Planning Commission Regular Meeting

Planning Commission Staff Report

Subject: Stouffer Residence Landmarking, Restoration, and Addition
(Class A Major Development Permit, Preliminary Hearing; PL-2025-0355)

Proposal: A proposal to locally landmark and rehabilitate an existing historic primary residence, demolition of the non-historic saltbox addition, and a new addition in the rear of the lot. The project proposes 3,668 sq. ft. of total density which includes three (3) bedrooms, five (5) bathrooms, an office, an accessory dwelling unit (430 sq. ft.), and a two-car garage (500 sq. ft.). The historic barn will also be fully rehabilitated. The project includes (1) one gas fireplace and 489 sq. ft. of heated paving and walkways.

The images below outline the approximate location of the existing conditions and the proposed conditions.

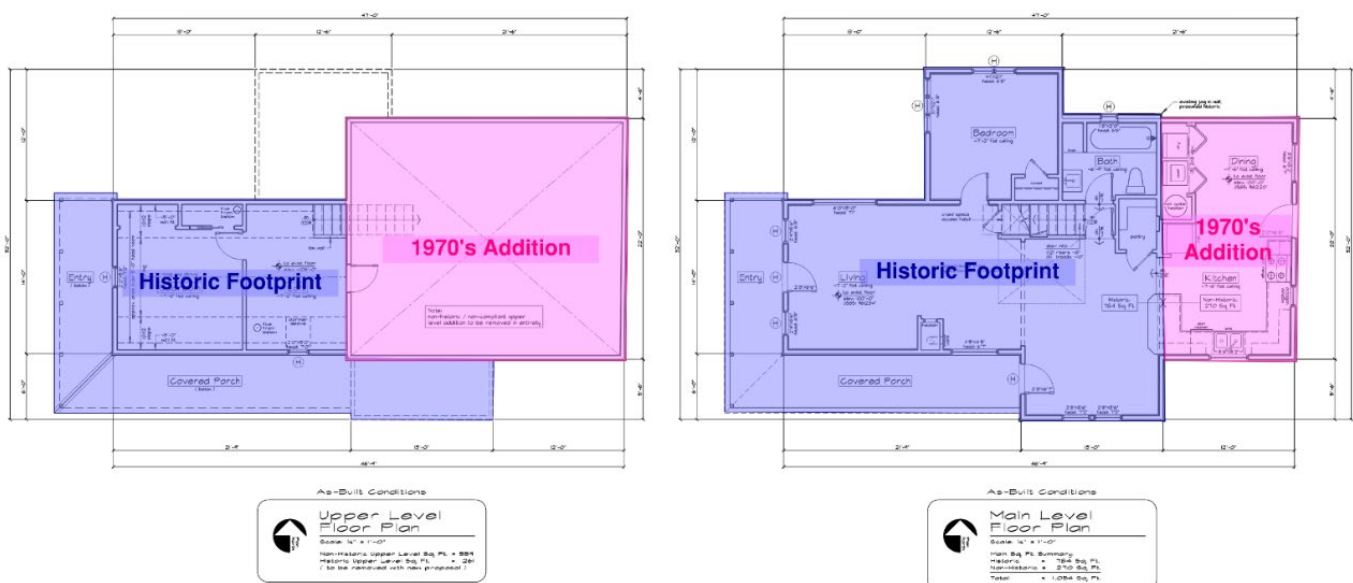
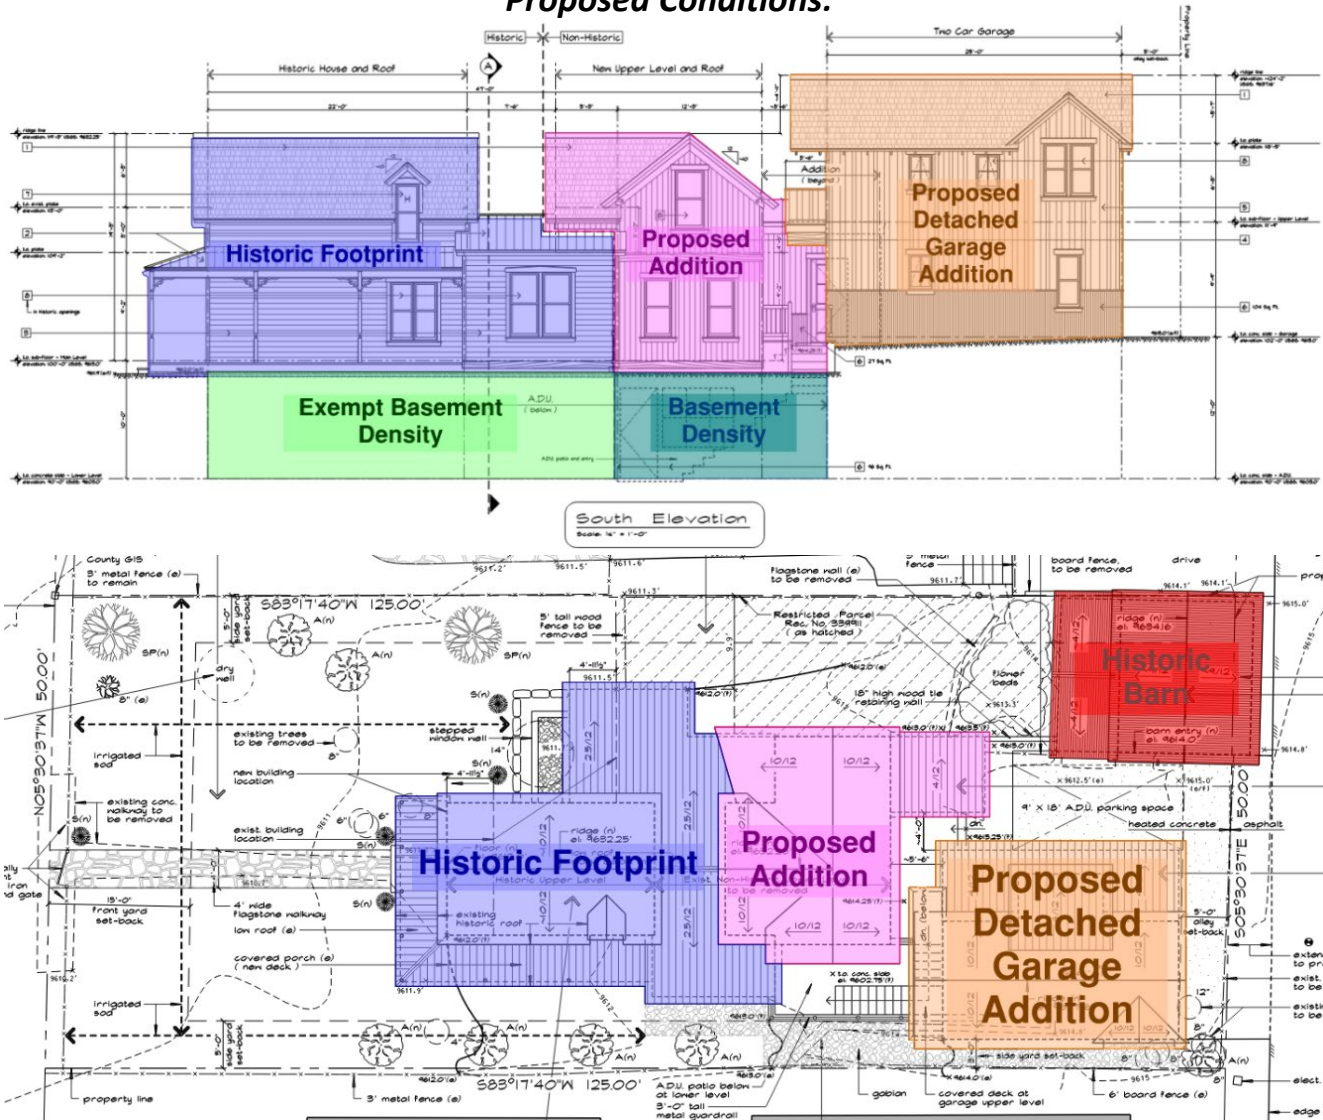
The applicant proposes to relocate the historic primary structure 4'11" to the west from the original location. Moving the structure west from the center of the lot allows for area to relocate the parking to the rear and create space for additional programming desired of a modern residence. Staff finds this proposal is subject to the assignment of points under [Policy 24, section G](#). Staff finds the proposal warrants the assignment of negative ten (-10) points for the relocation of a historic primary structures less than 5 feet from its current or original location, keeping the structure on its original site, and maintaining the historic orientation and context of the structure and lot.

Site Plan: The project follows the historic settlement pattern for this block (Priority Design Standard 4). It also matches the Town grid (Priority Design Standard 5). Staff believes moving the historic structure 4’ 11” west improves alignment with the general pattern of the historic homes on the block. While maintaining some variation, this adjustment reinforces the visual unity of the block and meets Priority Design Standard 8.

As-Built Floor Plans

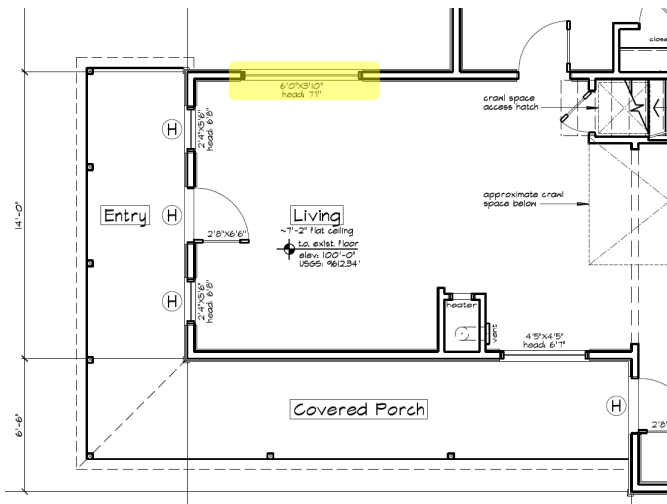
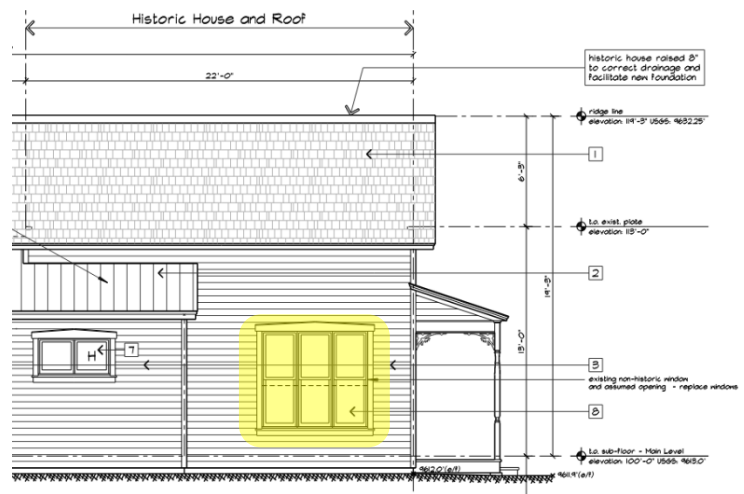
The applicant is proposing three window changes on the main level and one window change on the second level of the residence. Two of the windows on the main level are proposed to be restorative efforts to remove non-historic windows and replace with code-compliant windows within the existing historic openings. Additionally, one window on the north façade of the living room is proposed to be replaced but without consideration for the historic opening (see photo below). As shown in the picture on the left, the existing window opening has a dimension of 6' (W) x 3' 10" (H). The proposed

window on the elevation, shown on the right, has an estimated dimension of 6' (W) x 5' 6" (H) which could increase the window opening to a larger dimension than what existed prior to the non-historic window. Staff believes this window opening should be restored to its historic dimensions, although the historic window was previously replaced. As the proposed plans do not provide exact dimensions for the new window, staff requests the applicant submit detailed measurements of the existing opening and the proposed window opening. This will ensure that no further enlargement of the opening occurs, preventing any additional loss of historical fabric. As outlined by the Handbook of Design Standards, the loss of historic fabric warrants negative three (-3) points.
